City of Santa Barbara California

PLANNING COMMISSION STAFF REPORT

REPORT DATE: May 1, 2008
AGENDA DATE: May 8, 2008
PROJECT ADDRESS: 528 Anacapa Street (MST2006-00748)
TO: Planning Commission
FROM: Planning Division, (805) 564-5470
 Jan Hubbell, AICP, Senior Planner
 Irma Unzueta, Project Planner

South Elevation
1/8" = 1'-0"

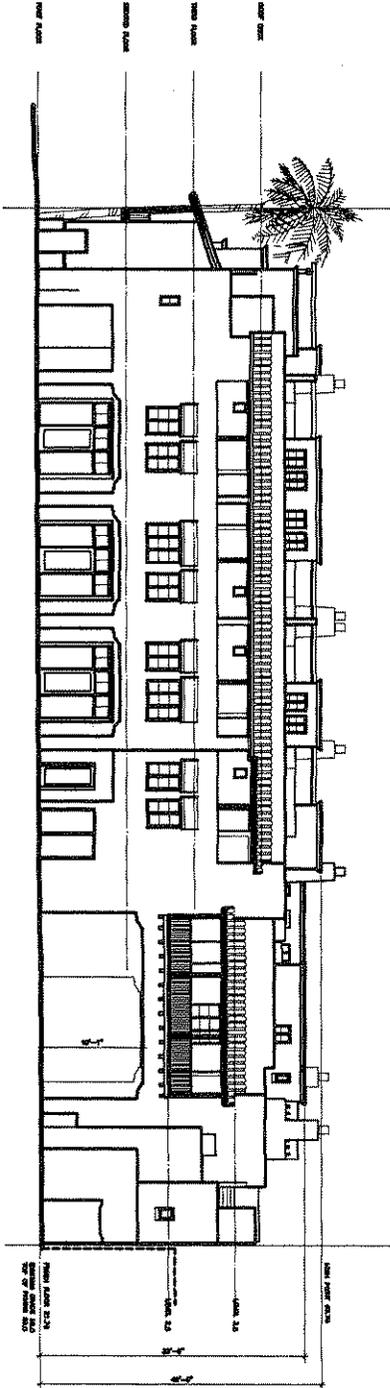
- 4) The Board is not in favor of the high wrought iron fence on Cota Street.
- 5) The south elevation lacks detail and design. The south elevation is important and should have cohesiveness in its architecture to the rest of the building. One suggestion is to set back and off-set some facades on the south elevation.

- 4) The new revised south elevation is nicely articulated.
 - 5) The overall height reduction is appreciated.
 - 6) The Board appreciates the increased building setback on Cota Street.
